TO: Town of Haymarket Planning Commission
SUBJECT: Haymarket Ice Rink - Preliminary Site Plan
DATE: 09/09/13

SUBJECT: HAYMARKET ICE RINK PRELIMINARY PLAN 3RD SUBMISSION COMMENTS

RE: Haymarket Ice Rink Expansion
Preliminary Site Plan PRE20130415 Second Submission
ccl Project #: 09090.005.00

HAYMARKET ICE RINK EXPANSION PRELIMINARY SITE PLAN

PRELIMINARY LANDSCAPE PLAN

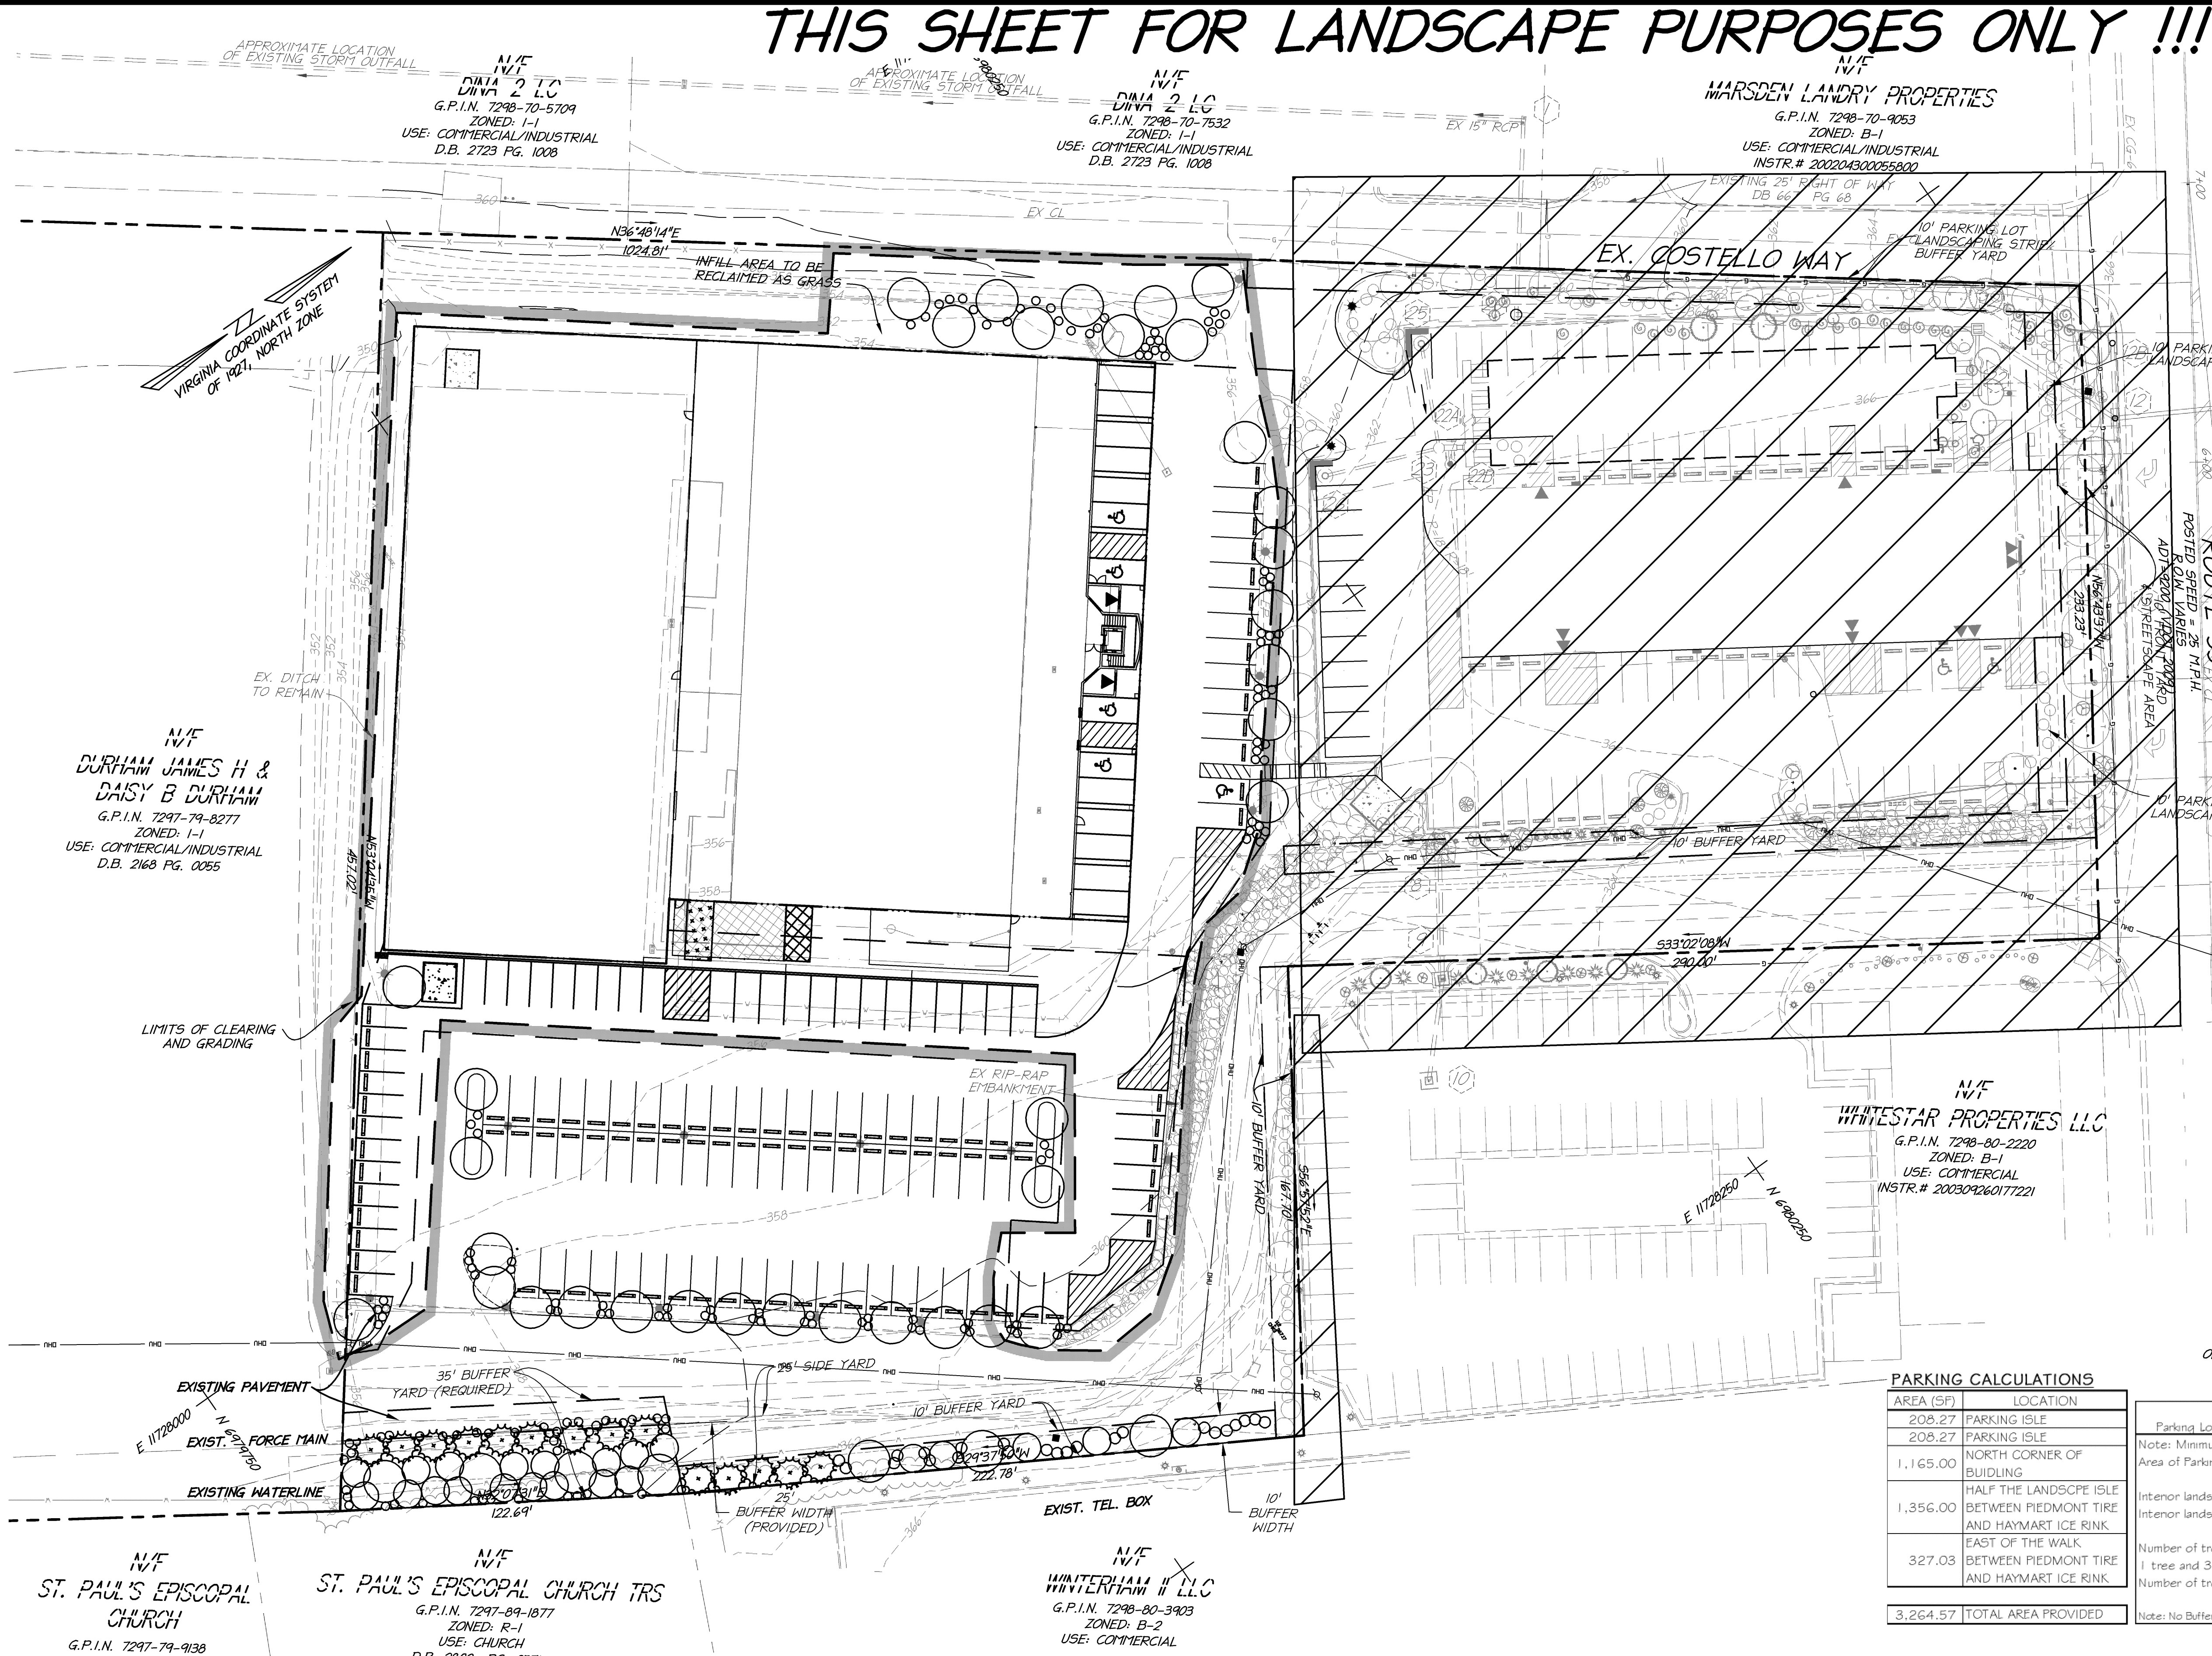
3. Add an Open Space tabulation to the Landscape Plan as quoted in the wavier and as shown on the original approved plan.

4. In the Parking Lot Adjacent to Private Street table:
 - a. Change Costello Way to Private Street (Costello Way is the street on the north side of the site).

- b. Verify the totals of trees, shrubs and evergreen trees – they do not match the plan.

5. On the Landscaping Plan, add a provided and required table for Parking Lot Adjacent to Parking Lot for the 13 new spaces on the SW property line.

6. Check the landscaping plan for conflicts:
 - a. Move the evergreen tree in conflict with the canopy tree on the right side of the south entrance.

- b. The trees shown in between the parking lot and the private road matches the original approved plan. However, this plan shows that there are several conflicts with the existing lights. Verify which trees/shrubs are actually planted in this location.

Status: Label the corresponding area on the Landscape Plan, Sheet 3, as part of the Final Site Plan Submission.

Response: As shown on the original site plan, an Open Space tabulation has been added to the landscape plan sheet 03.

Response: The label on the landscape table has been changed from Costello Way to Private Street as shown on plan sheet 03.

Response: The total counts of trees, shrubs and evergreens have been updated so the counts shown on the plan match what is shown in the tabulations.

Response: A table showing the required and provided landscaping for the buffer along the SW property line has been added to plan sheet 03.

Response: The evergreen tree has been removed so there is no conflict with the canopy tree as shown on plan Sheet 03.

Response: The locations of the trees shown on the plan have been updated so there are not conflicts with the existing lighting on site. See plan sheet 03.

Final Response: The area being reclaimed as a grass seeded area has been noted on the landscape plan, sheet 03.
